Meeting Agenda Plat Committee

Monday, October 24, 2022

KPB File 2022-152
T 05S R 12W SEC 27
Fritz Creek

KPB File # 2022-151
S30 T05N R09W
Sterling

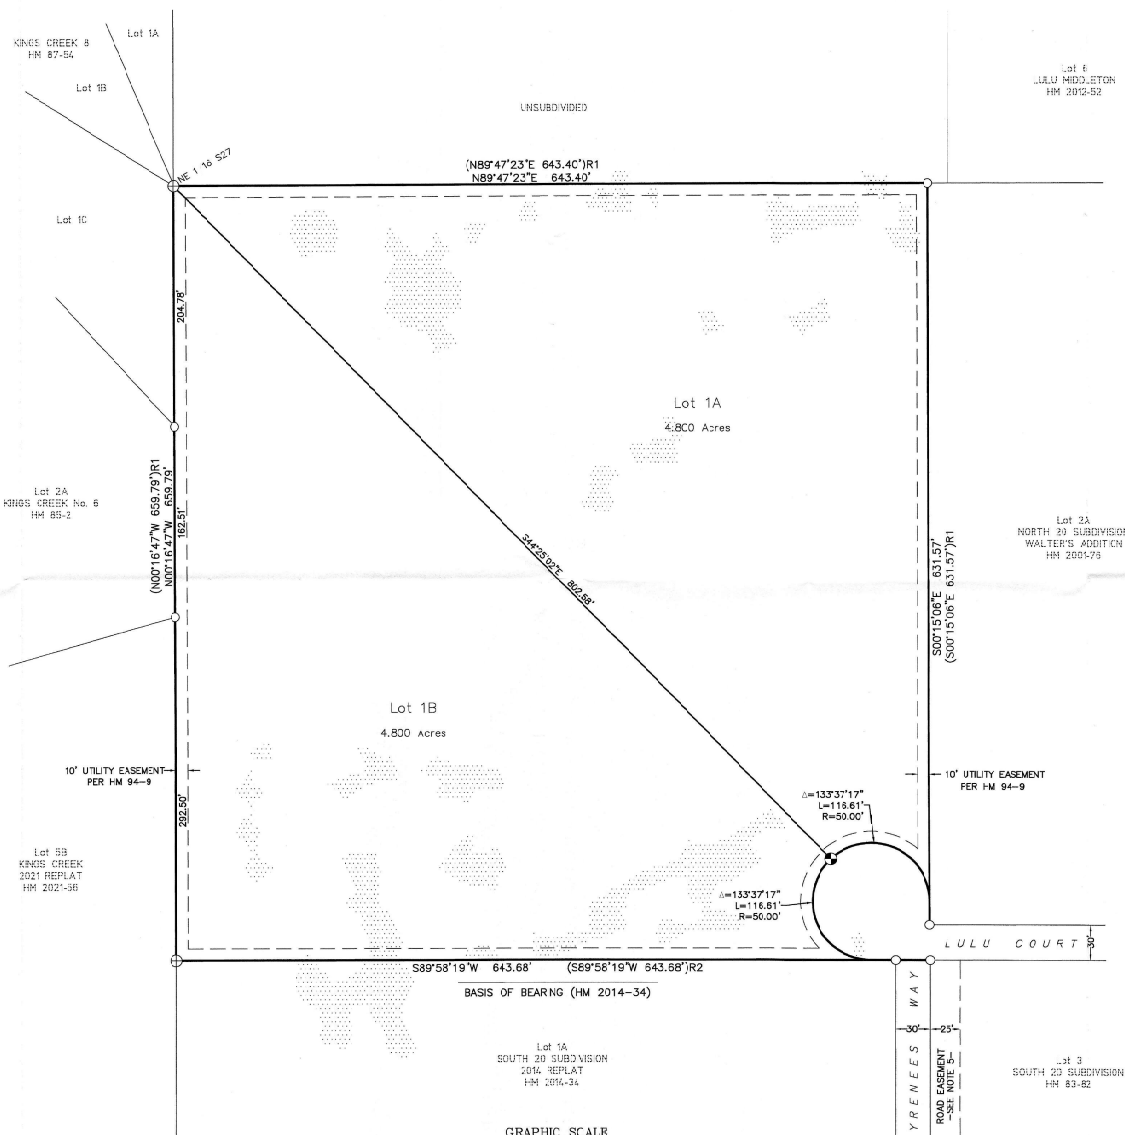
Staff recommendation: *Depict the setback or provide a typical depiction.*

- *Provide a plat note for any exceptions granted.*

Staff recommendation: *The owners' names should match how they took title and the certificate to plat has them listed. Add another notary acknowledgement or provide another blank for a third name if all signing at the same time. Comply with 20.60.190.*

KPB 2022-151

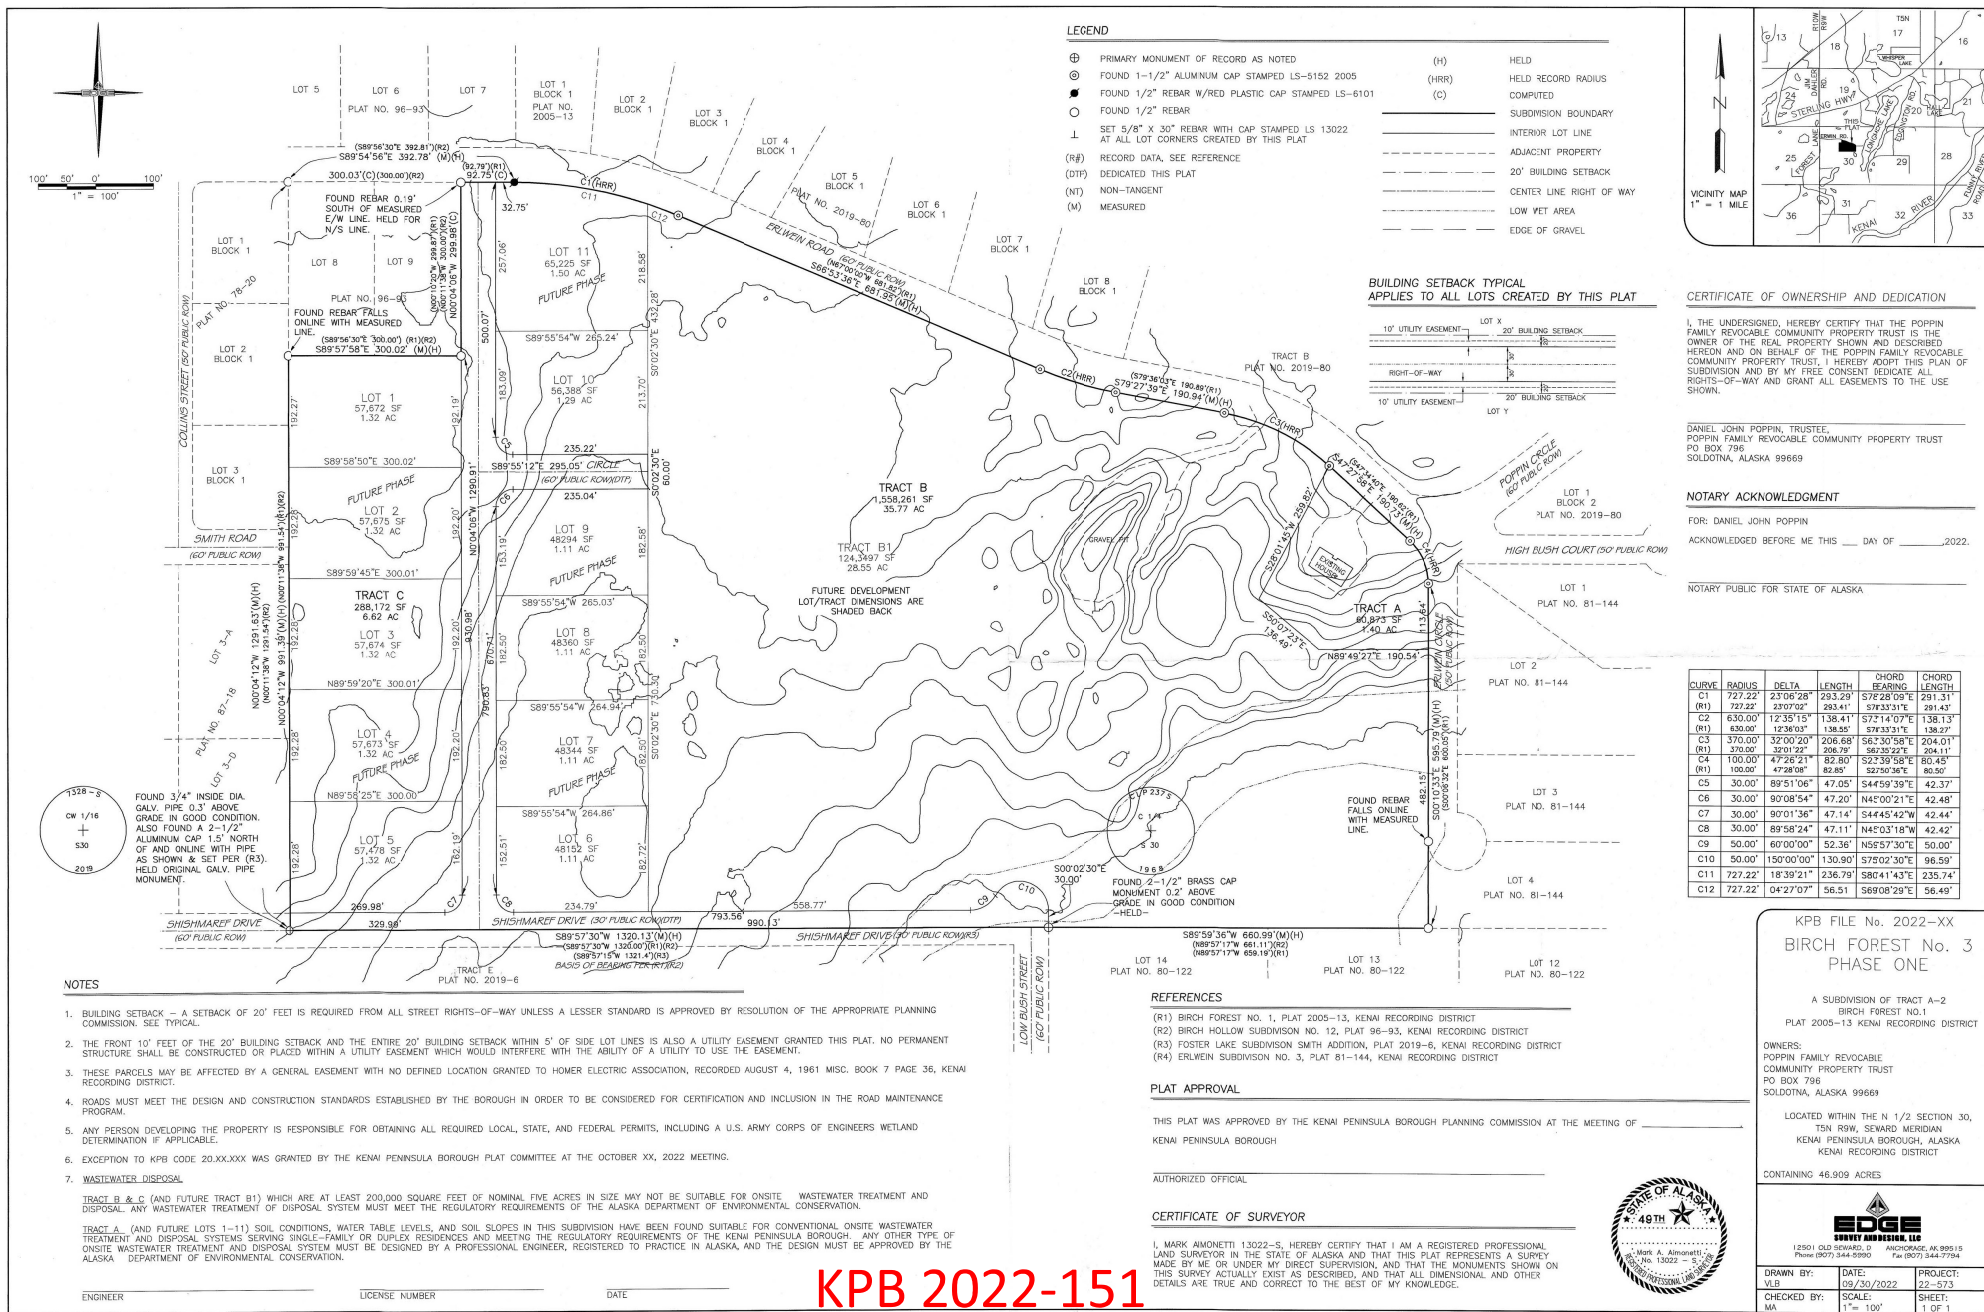
Staff recommendation: *Area from the original plat for Tract A-s was 46.987 ac., you have listed 46.909 ac. in the title block, please verify.*

- G. The status of adjacent lands within 100 feet of the proposed subdivision boundary or the land status across from any dedicated rights-of-way that adjoin the propose subdivision boundary, including names of subdivisions, lot lines, block numbers, lot numbers, rights-of-way; or an indication that the adjacent land is not subdivided;
Staff recommendation: *Update Poppin Circle to Court, High Bush Court was changed to Erlwein Road, Collins Street was changed to Frozen Street. Add block label for the lots south of the subdivision.*

- H. Approximate locations of low wet areas, areas subject to inundation, areas subject to flooding or storm water overflow, and the line of ordinary high water. This information may be provided on an additional sheet if showing these areas causes the preliminary plat to appear cluttered and/or difficult to read;
Staff recommendation: *Clarification of the wetland area may be needed.*

- L. Contours at suitable intervals when any roads are to be dedicated unless the planning director or commission finds evidence that road grades will not exceed 6 percent on arterial streets, and 10 percent on other streets;
Staff recommendation: *Verify for new dedications and for Erlwein Circle if requested by the plat committee.*

- B. Additional right-of-way or easement width may be required to provide for the construction of side slopes or to otherwise accommodate right-of-way construction standards set forth in KPB Title 14.
Staff recommendation: *Erlwein Circle is only dedicated as a 50 foot wide right-of-way, an additional 10 feet should be dedicated.*

Wastewater notes will be required to be updated depending on how the owner wishes to have his soils analysis test done. Remove “or nominal five acres.”

Staff Discussion: A through dedication of Smith Road should be provided to connect to the new north-south dedication proposed. This would provide a complete block for the area west of this subdivision and provide for projection and extension of the existing dedication.

KPB File 2022-091R1

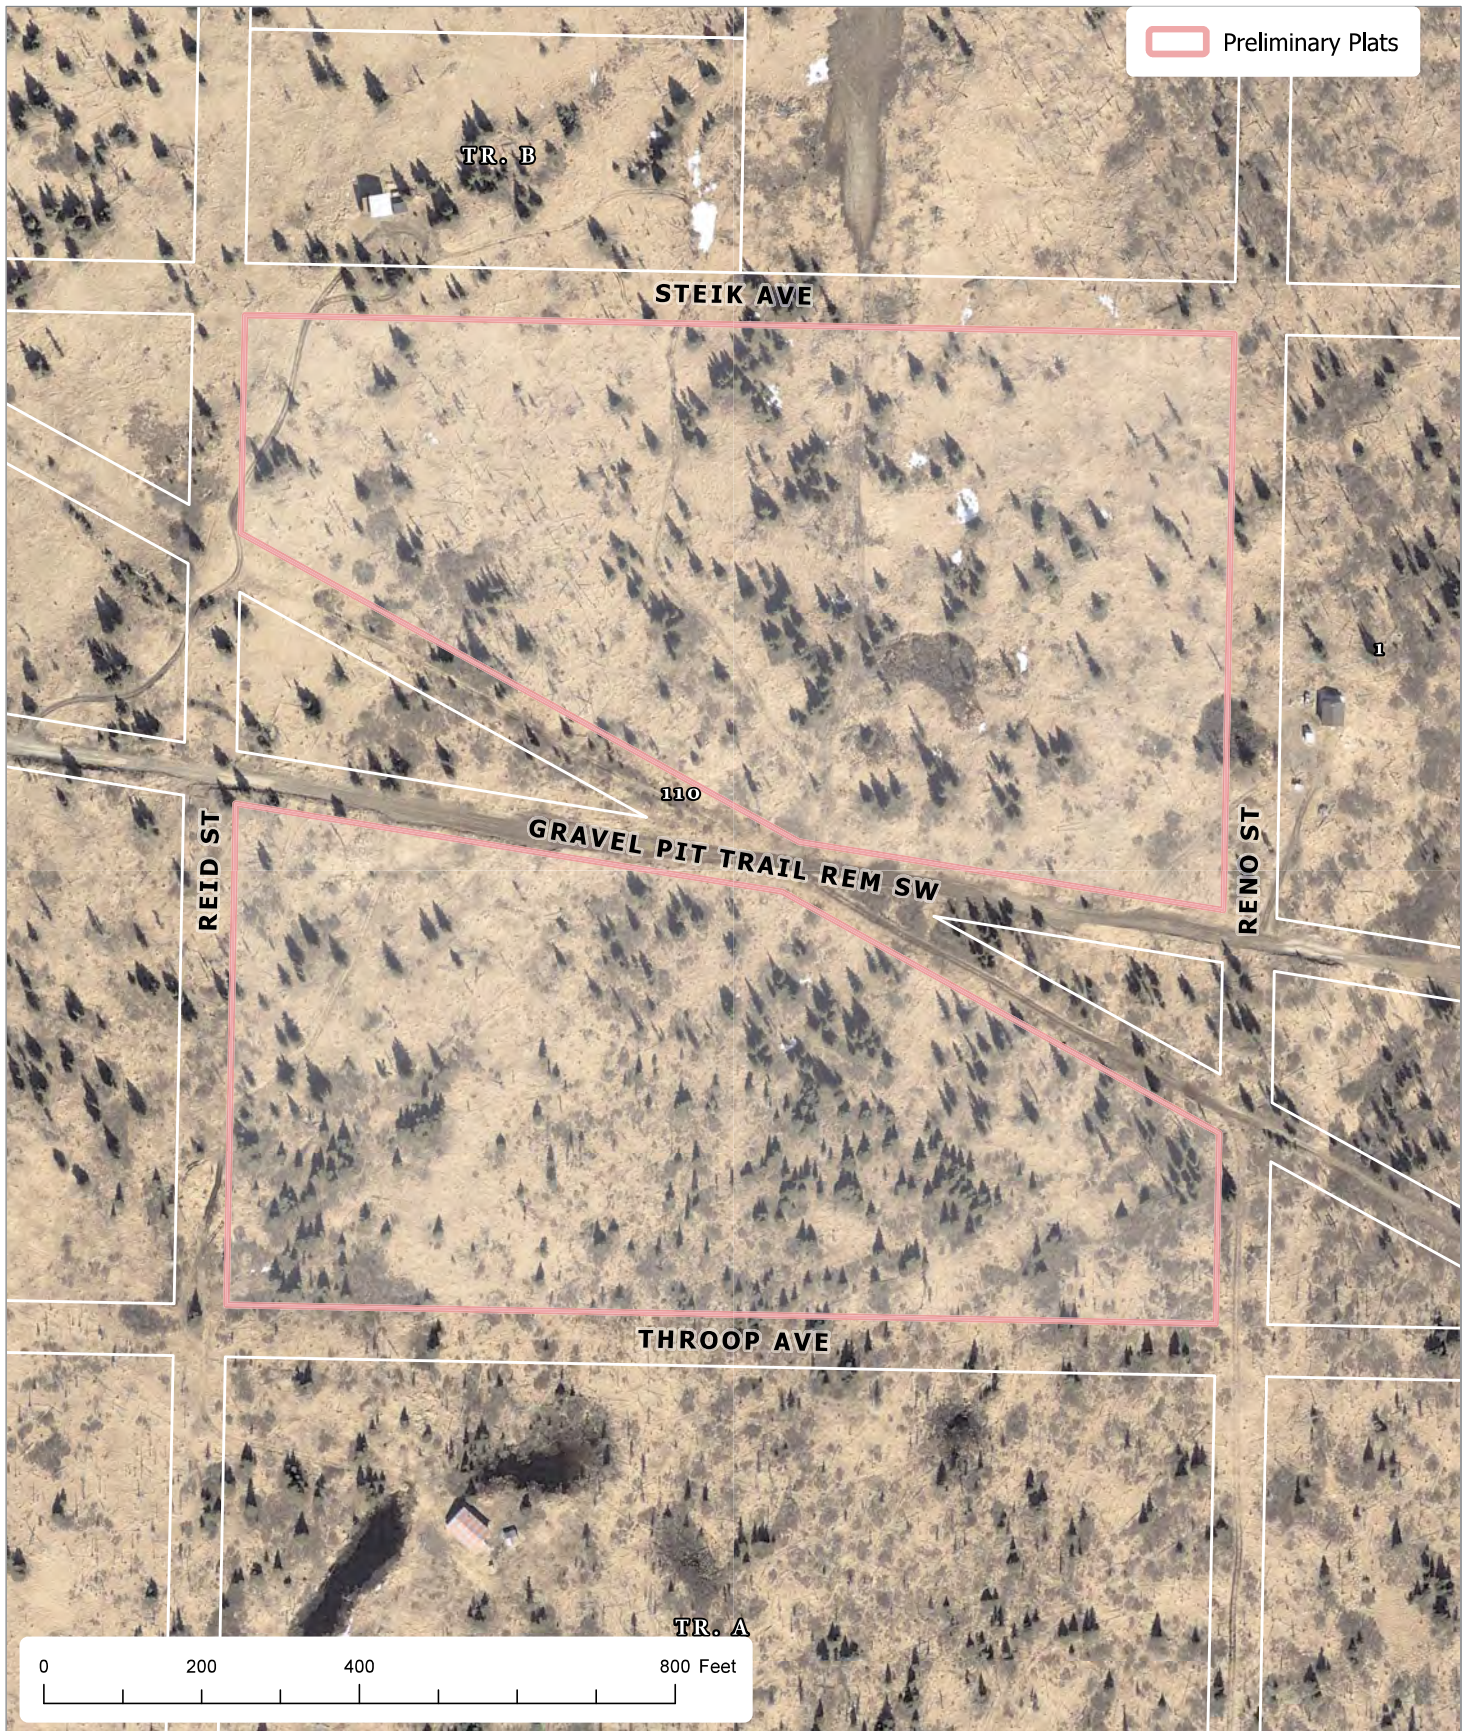
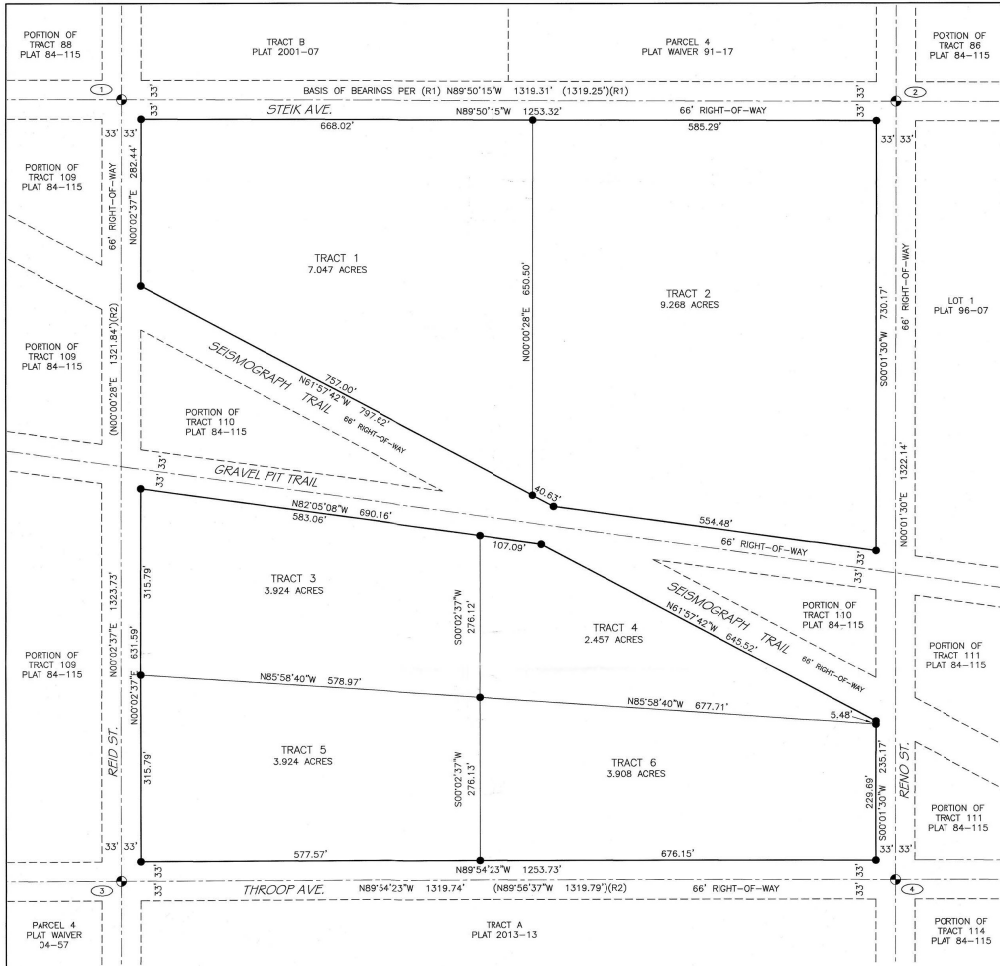
Utility Easements the Right of Way Map, HM 84-115, granted 10-foot-wide utility easements along the dedicated rights-of-way. Staff recommends revising plat note 3 slightly. A typical drawing is being included on the plat.

Staff recommendation: Since portions of the NE1/4 NW1/4 are being excluded from this plat the title block should be revised to state “excluding those portions between seismograph rights-of-way and Reid Street and Reno Street. Verify final acreage and update accordingly.

Revise the following plat notes.

Show distances and bearings between lots on east and west where stopped by at roads.
